Agenda Item: The Grove at Shoal Creek Planned Unit Development

Staff from the City of Austin Development Services and Transportation Departments have reviewed the revised Traffic Impact Analysis for the Bull Creek Parcel development proposal (hereafter called "The Grove") and offer the following comments:

As part of the review of the February 2, 2016 revision of the traffic report regarding the "*The Grove at Shoal Creek, Traffic Impact Analysis*", prepared by R-K Traffic Engineering, LLC, the Austin Transportation Department (ATD) has additional comments related to the final detailed design documents that must be addressed as part of the site plan review process.

The Grove PUD Erosion Assessment

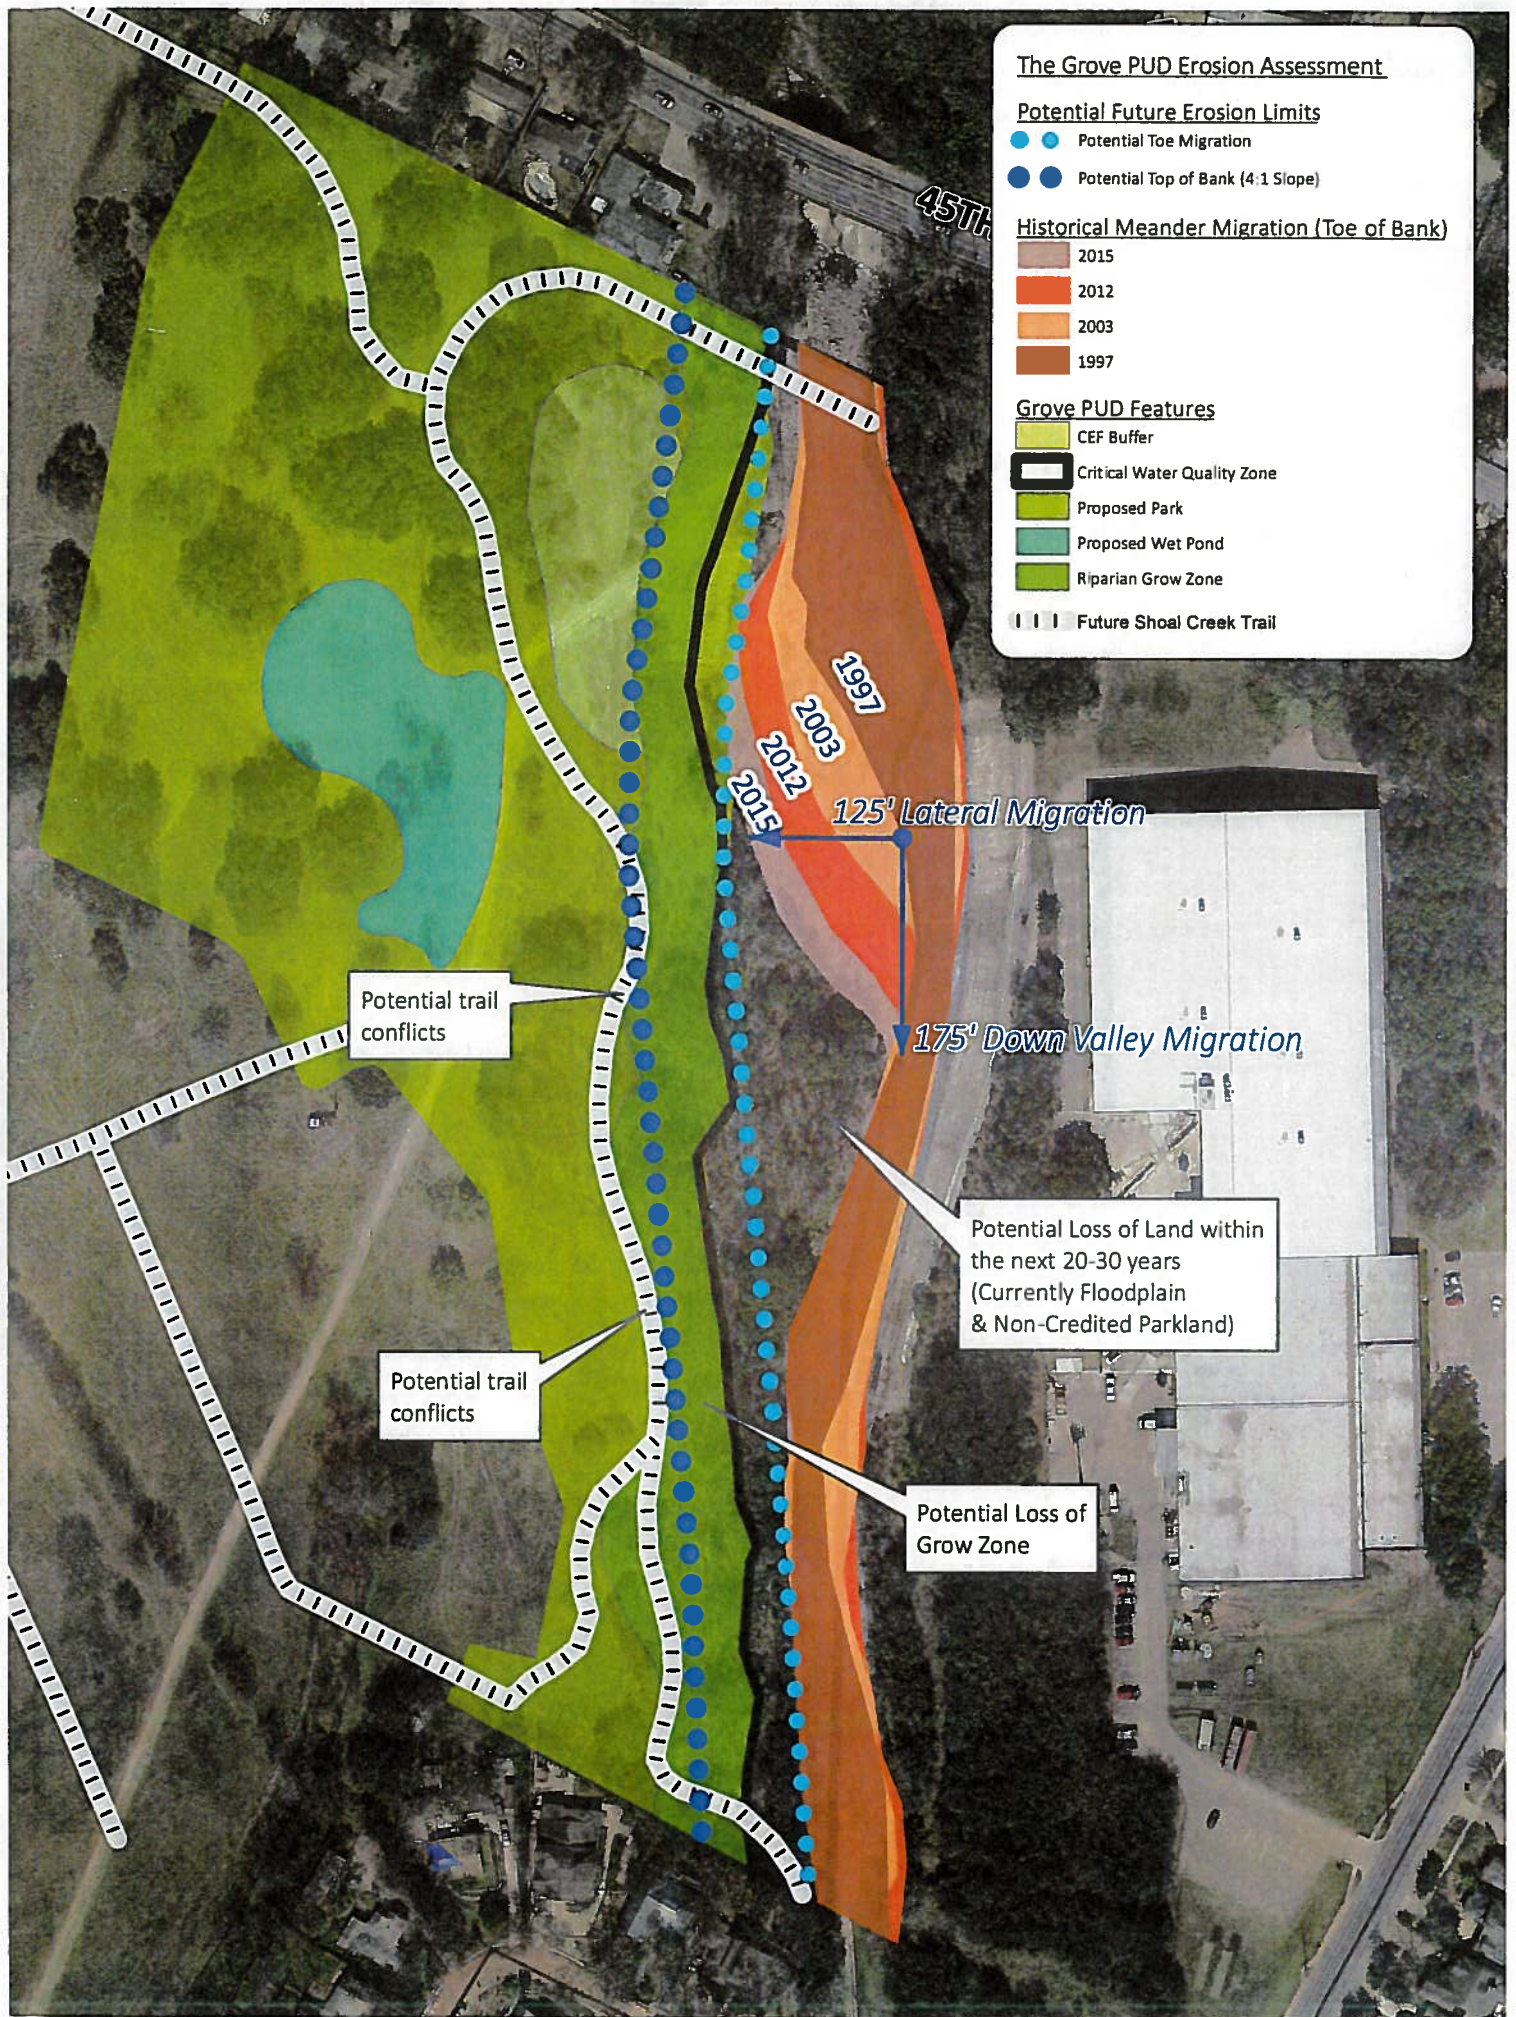
Directly upstream of 45th Street, the channel is mostly situated in bedrock (Buda formation). On the subject property, the channel banks are Del Rio clay formation and vulnerable to weathering and erosion. The stretch of Shoal creek from 45th Street to 38th street is a relatively straight channel with mildly curved bends, suggesting that severe meanders are not likely to develop. It is possible that this particular erosion location is highly affected from the bridge hydraulics and sudden change in geology downstream of 45th Street.

While it is difficult to precisely predict the evolution of urban streams that are highly impacted by the built environment, the erosion does show a consistent pattern of downstream migration – approximately 175' in 18 years. It is reasonable to assume that this pattern will continue as shown in the attached map, with the rate of movement dependent upon storm events. The downstream migration is expected to taper off as the stream reaches a pattern that mimics the historically stable downstream conditions. It is also reasonable to believe that the erosion will stabilize as the influence of the bridge hydraulics lessens further downstream.

The attached map shows two blue dotted lines that show the predicted toe of slope (light blue) and top of bank (dark blue).

Three levels of projects could be considered to address this erosion should it be deemed a problem. A standard capital planning level cost estimate for streambank stabilization project assumes full bank restoration designed by an outside engineering firm and constructed by a private contractor. This project would be a major undertaking and likely excessive for the actual need; however it is used as a starting point and less invasive projects are considered based on a factor of reduction. A more detailed cost analysis could be developed given more time.
